**Historic Preservation Review City Hall - 1711 Miner Street,  
Idaho Springs, CO 80452 Agenda**

# IDAHO SPRINGS HPRC STAFF REPORT

## **Certificate of Appropriateness (COA) COA26-001 – Entry Ramp at 1921 Virginia Street**

## **Certificate of Appropriateness (COA) COA26-002 – Entry Door, Window Replacement, and Mechanical Equipment at 1743 Miner Street**

A3.1

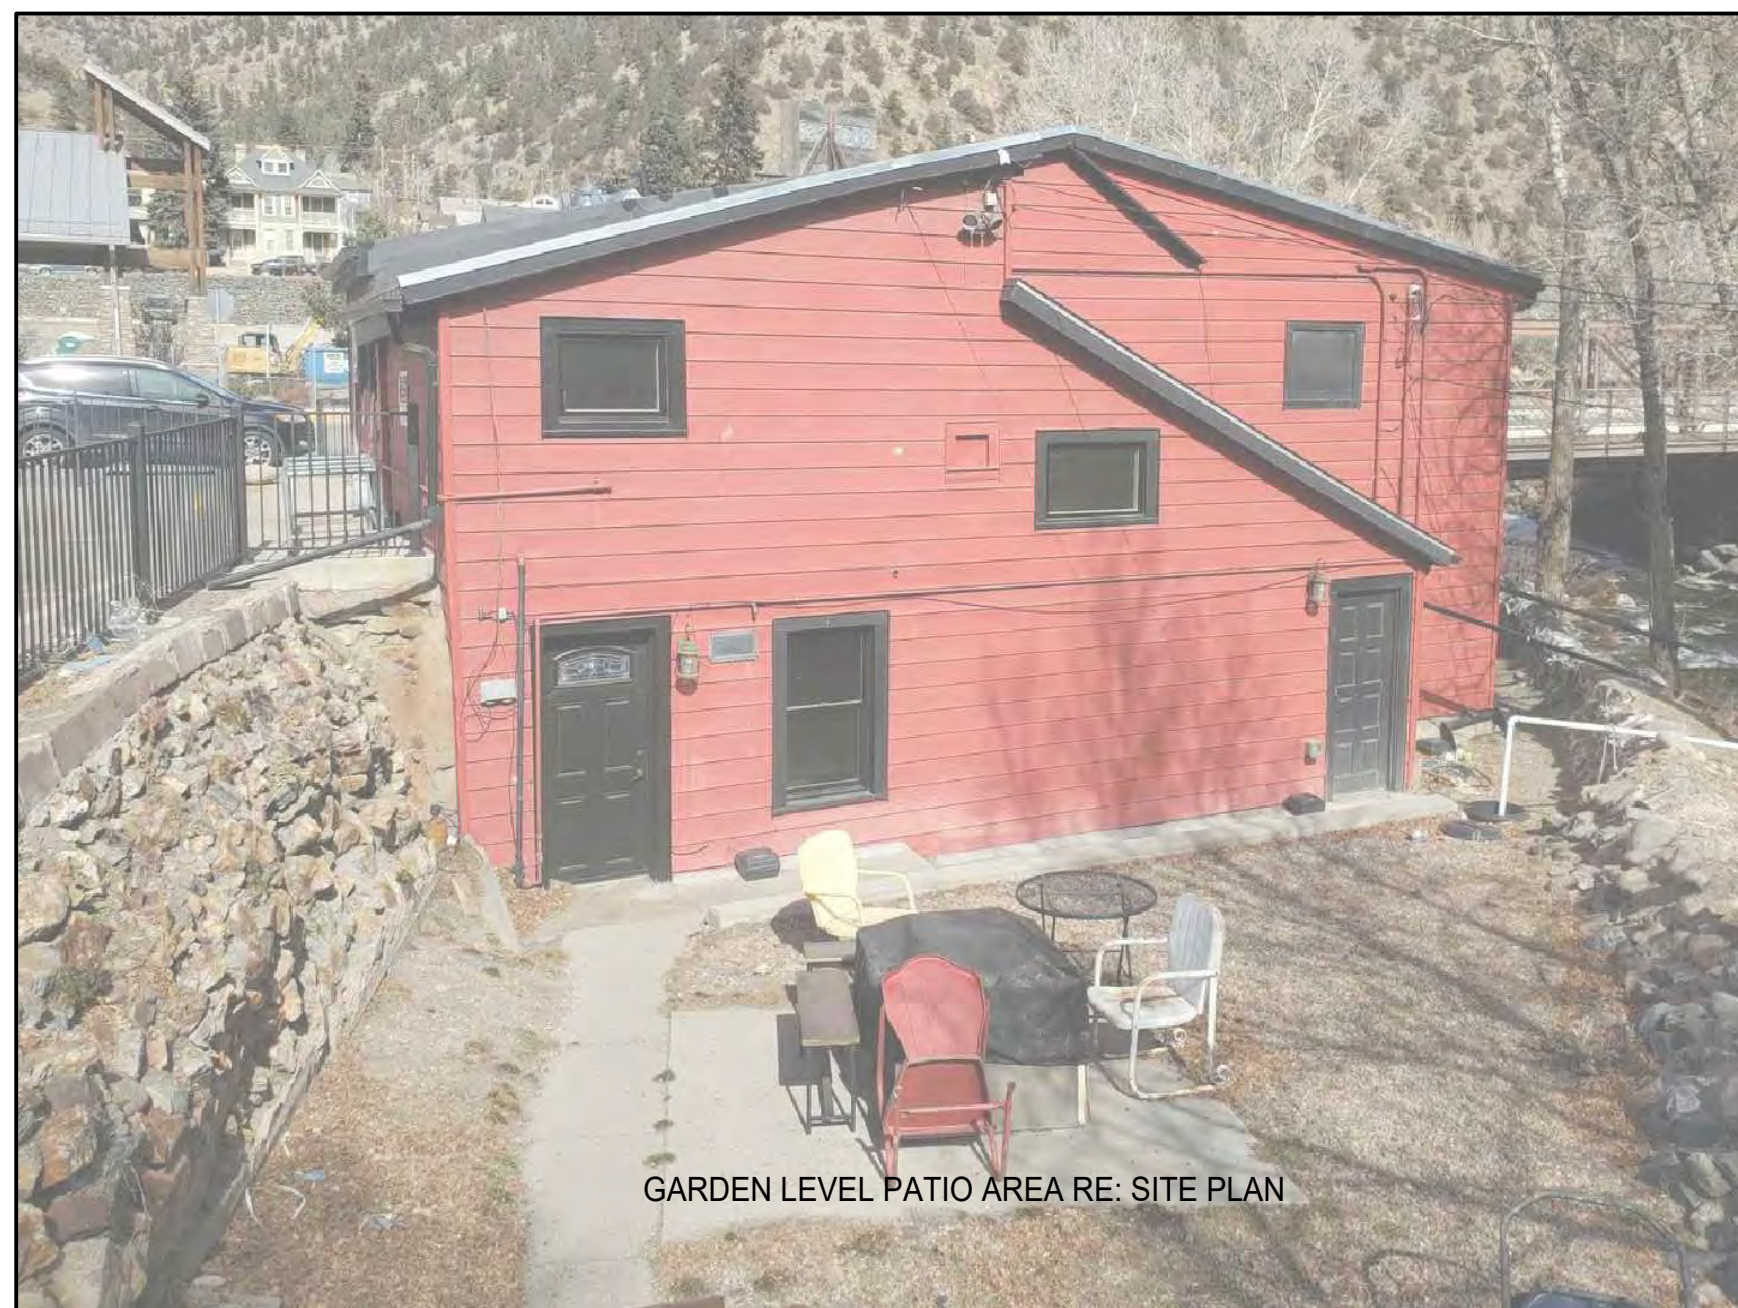
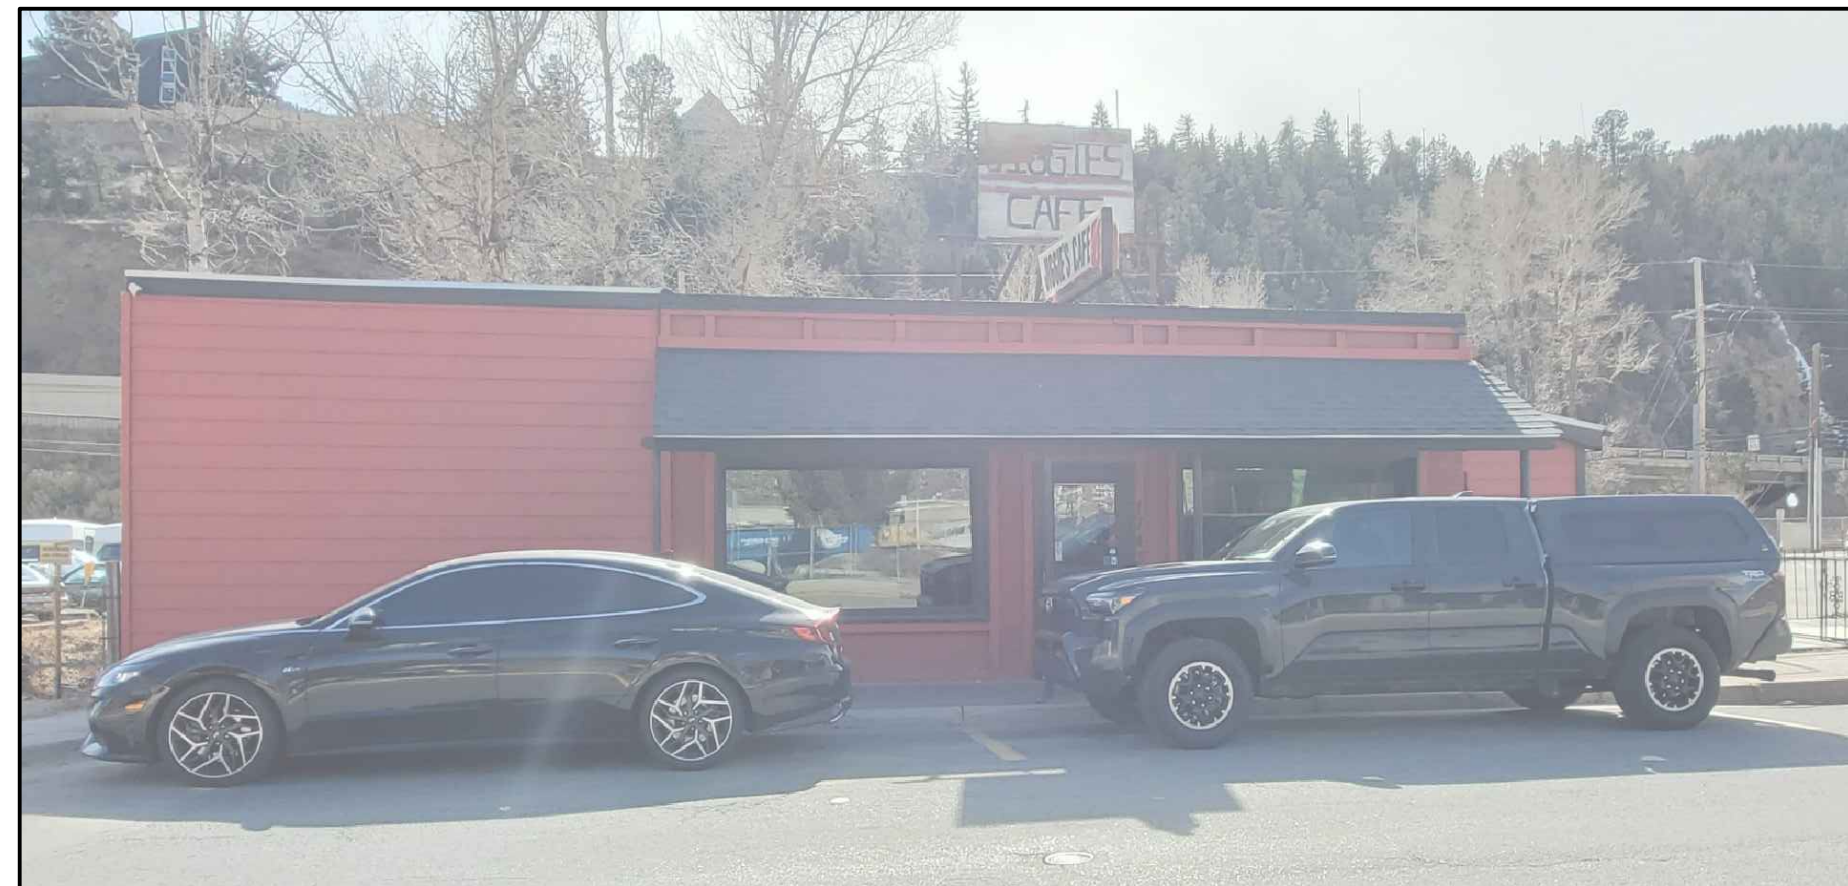
The proposed work is depicted on the elevation drawing below. The proposed work includes a new exterior door on the western façade of the building, which will provide egress to their existing exterior patio space from the interior of the building. The applicant proposes that the door will match the existing front door on the north façade of the building.

The *Design Guidelines for Historic Structures* provides an exemption for small mechanical installations that are screened from view and do not exceed 3' by 2.5' by 2.5'. The proposed mechanical equipment is larger than the exemption would allow, so is included in this review. The applicant proposes to paint the mechanical equipment to match the existing trim of the building to help it blend in with the rest of the building.

The existing building is a noncontributing building, built in 1938. *The City of Idaho Springs Historic Resources Survey Plan, 2022*, states that the building's architectural type is "commercial" and its integrity level is "low". Given that the applicant proposes to source a door similar to the existing front entry door, staff believe that this is consistent with the existing structure and will not detract from the building's historic qualities.

1. The new door proposed for the west façade of the building shall match the front door of the existing building to the maximum extent possible, matching materials found elsewhere in the Historic District.
2. Roof-mounted mechanical equipment shall be painted to blend in with the surrounding building and shall be screened from street view.
